Amendments to the Drawings:

ARGUMENTS/REMARKS

FIG. 2

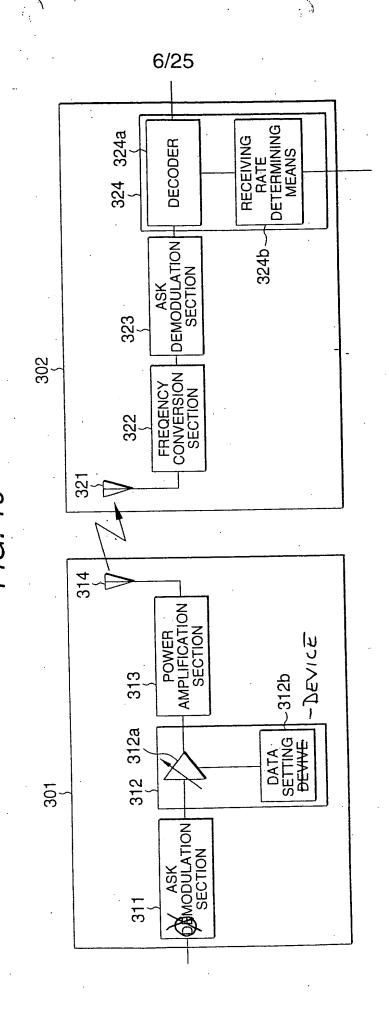
The examiner objects to figures 2 and 10 for errors. The proposed drawing amendments have been submitted to correct these errors and additional errors, making the objection moot.

The attached sheets of drawings include a sheet including Figs. 1 and 2 and showing changes to Fig. 2 which should replace the original sheet including Figs. 1 and 2; a sheet including Fig. 10 and showing changes to Fig. 10 to replace the original sheet including Fig. 10; a sheet including Figs. 13 and 14 and showing changes to both Figs. 13 and 14 for replacing the original sheet including Figs. 13 and 14; and a sheet including Fig. 21 and showing changes to Fig. 21 to replace the original sheet including Fig. 21. Errors in these figures have been corrected.
